PRODUCT ALERT NOTICE

Alert Ref No: CA cobas u 701: Enhanced handling of very high-mucus crowded samples QN-RDS-CoreLab-2025-099

System Affected: cobas u 701

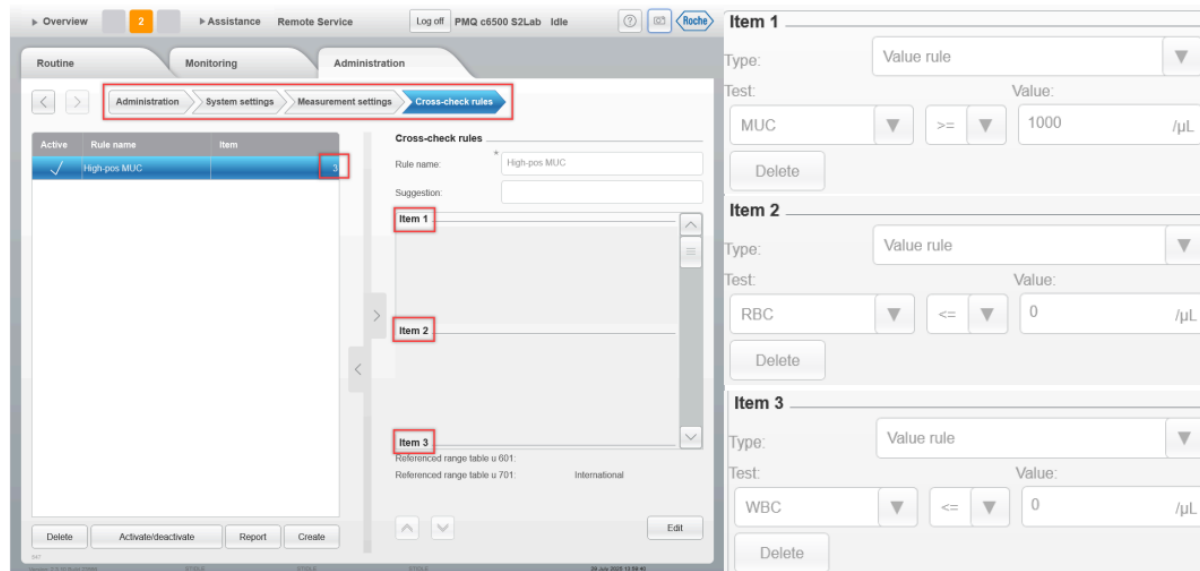
Set up a 3-condition cross-check rule on the **cobas u 701** to flag samples for review when the following conditions are met:

MUC $\geq$ 1000 particles/ μ L AND WBC $\leq$ 0 AND RBC $\leq$ 0

Create the cross-check rule under Administration > System settings > Measurement settings > Cross-check rule:

MUC in Conventional Units:

In conventional units, MUC is set to 1000 particles/μL.

MUC in Field of View Units:

For field of view units, the equivalent measurement is 227.27 particles/HPF, where the conversion factor from particles/μL to particles/HPF is 0.227.
